Planning Committee Meeting to be held at
Preston Town Hall,
284 Gower Street Preston
on Monday 8 February 2021 at 6.30pm.

**5.1 APPLICATION FOR PLANNING PERMIT D/200/2019
24-26 RATHCOWN ROAD RESERVOIR**

That Planning Permit Application No. D/200/2019 be supported and a Notice of Decision to Grant a Permit be issued subject to the following conditions:

PROJECT:	
PROPOSED DEVELOPMENT AT 24 - 26 RATHCOWN RD, RESERVOIR, 3073	
TITLE: GROUND FLOOR PLAN AND SITE PLAN	
PROJECT NO.:	2019168005
SCALE:	1: 100
DATE:	SEP 2020
CLIENT:	KELVIN CHENG
DRAWN BY:	LE ZHANG
CHECK BY:	YULUN (DAVID) PAI
DATE:	APR 2019
REVISION:	NO.
SEP 2020	RPI
	A
	B

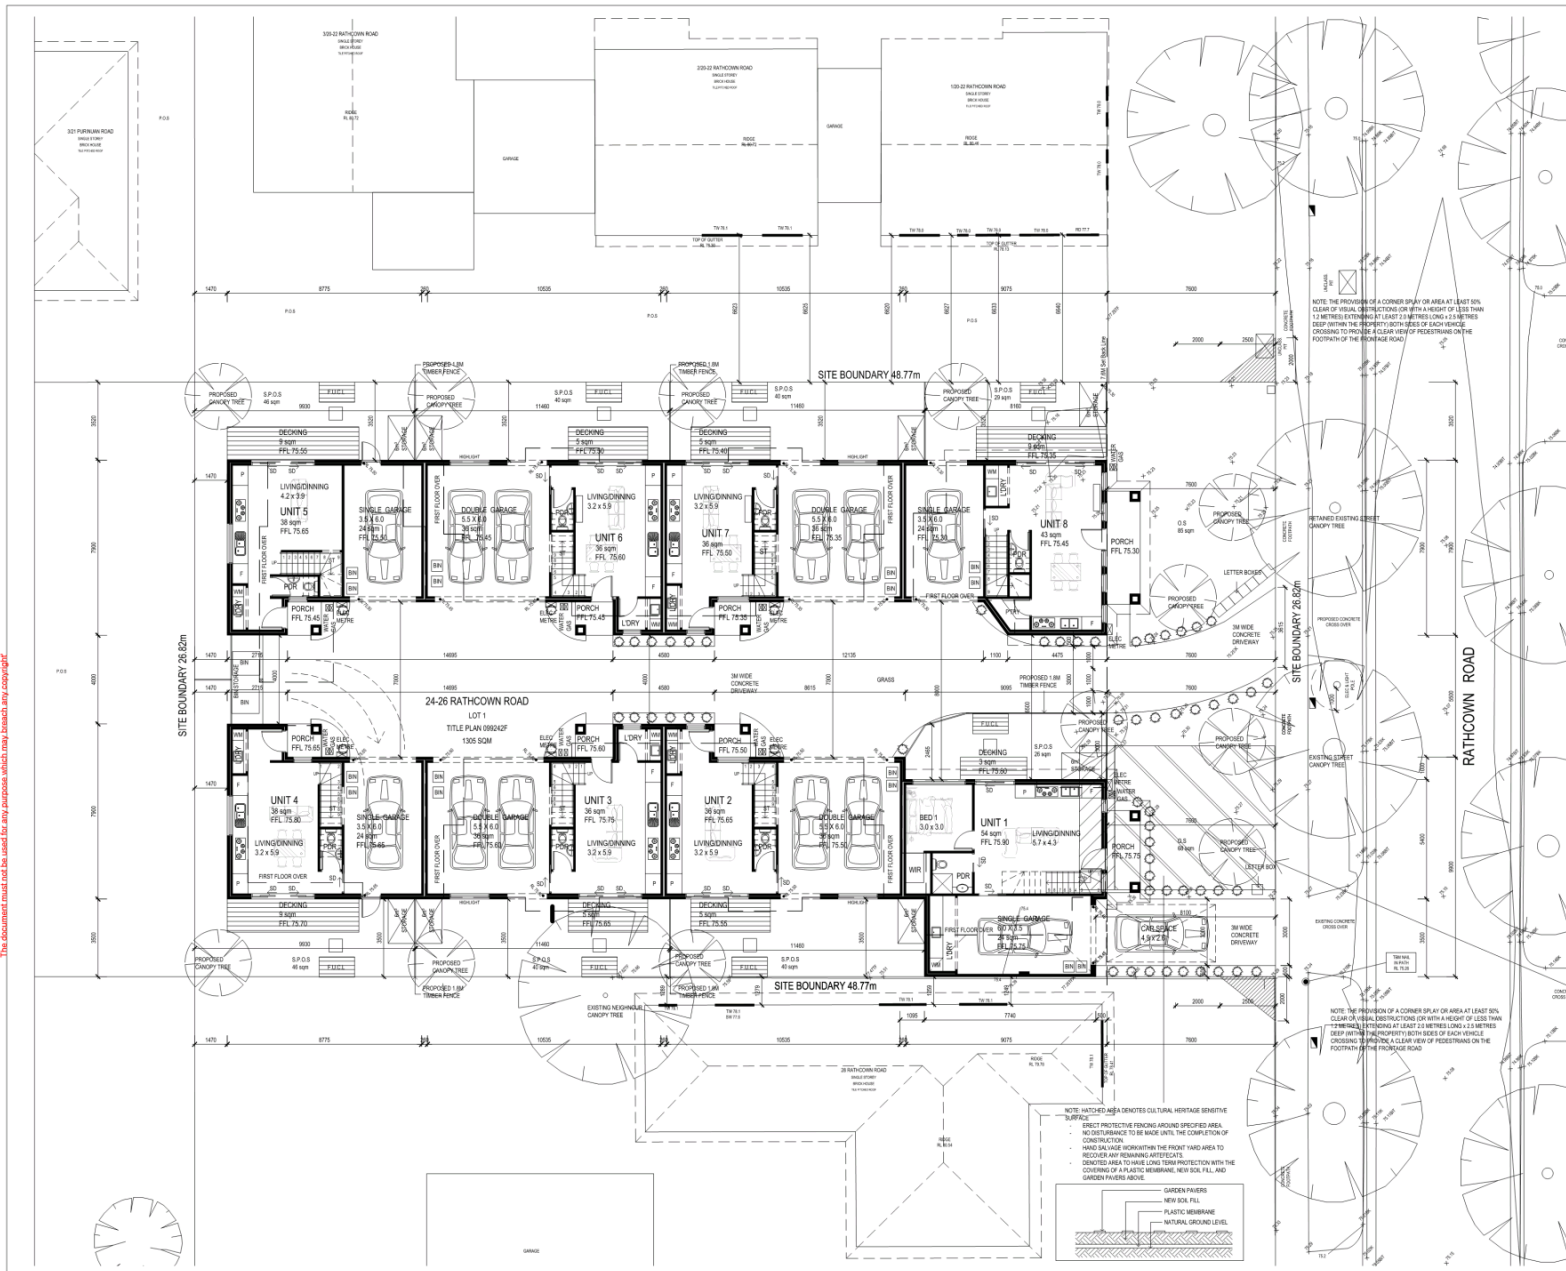
The proposal includes sufficient storage area to accommodate waste and recycling bins for each dwelling, including suitable access to the bin enclosure which is to be managed via private waste collection. Notwithstanding, the waste storage area located at the northern end of the driveway will provide a visually unpleasant vista from the street. Therefore, a condition will require the bin enclosure to be relocated to the northern boundary and screened using landscaping.

Furthermore, the plans erroneously show bins located within the individual garages of dwellings. Given that private waste collection is proposed, a condition will require the deletion of bins from individual garages of each dwelling.

Discussion Plan (Ground Floor)
 24-26 Rathcown Road, Reservoir: Proposed Development
 Prepared by Pai Property Consultants and Mecone
 18 November 2020

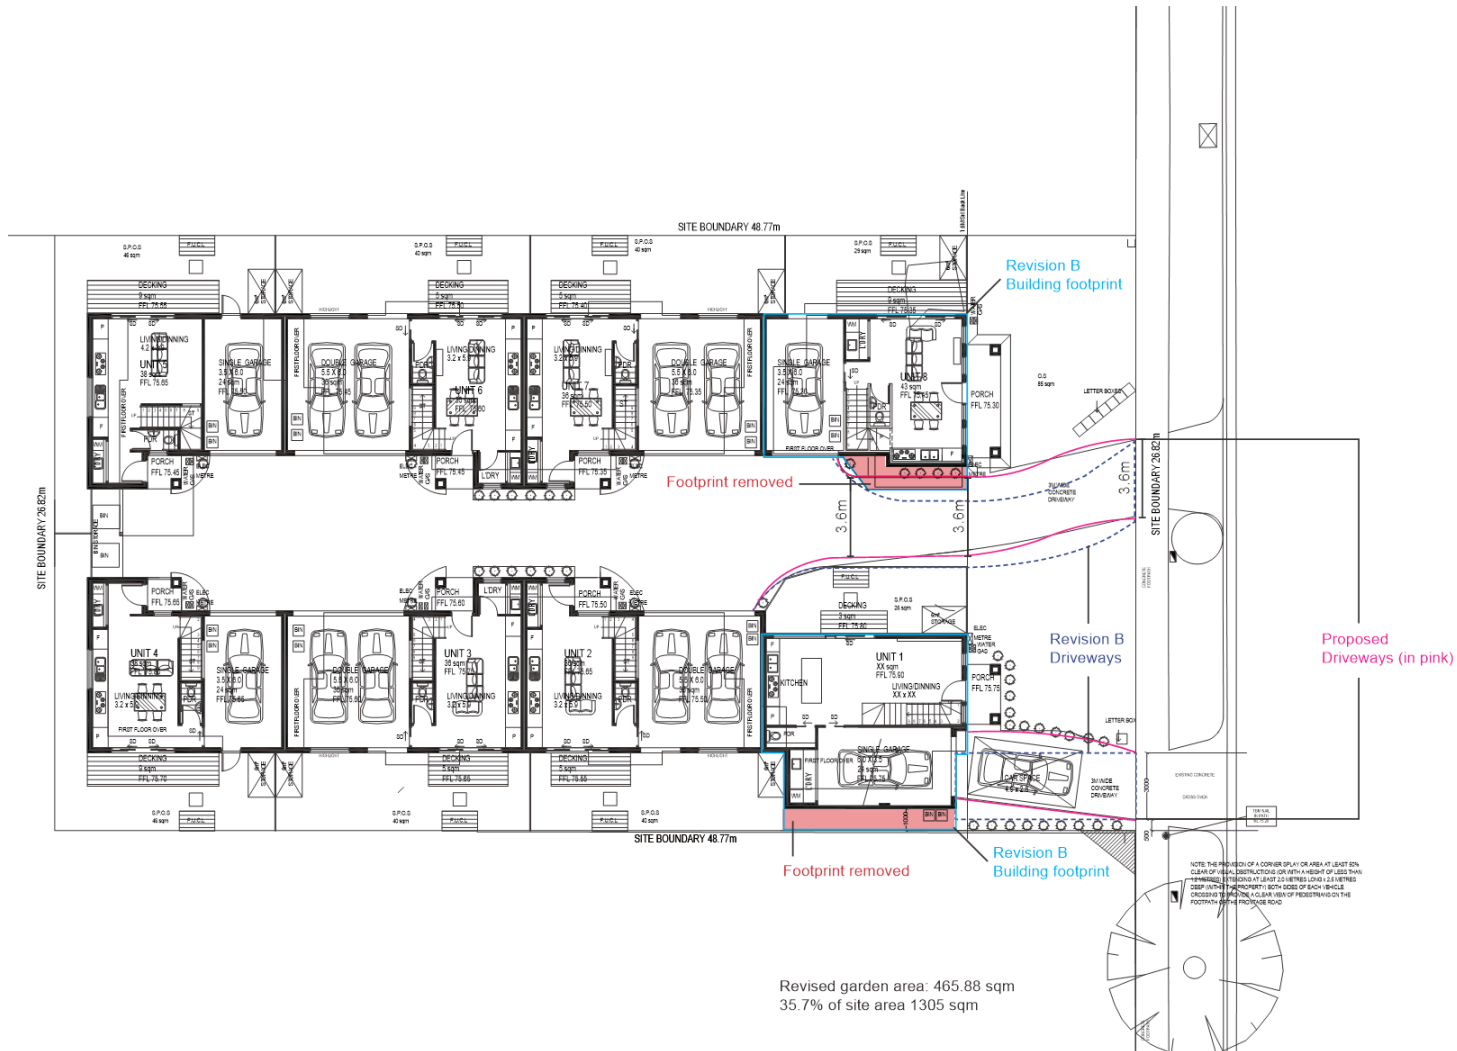
- (a) The garage wall of Dwelling 1 set back 1.0 metres from the western boundary and the re-alignment of the accessways to reflect what is depicted on the plan identified as 'Discussion Plan' (dated 18 November 2020).

It is noteworthy that conditions to correct the driveway alignment and increase the western boundary setback (discussed below) may impact the overall garden area calculation. In *Clayton Gardens Pty Ltd v Monash CC (Red Dot) [2019] VCAT 1138* the Tribunal commented that compliance with Clause 32.08-4 must occur at the time of the application and cannot be retrospectively conditioned.

As a result, the Applicant was asked to produce a discussion plan showing how the proposed conditions would impact the garden area calculation. The discussion plan demonstrates that the proposal will continue to comply with Clause 32.02-4 with the conditions imposed.
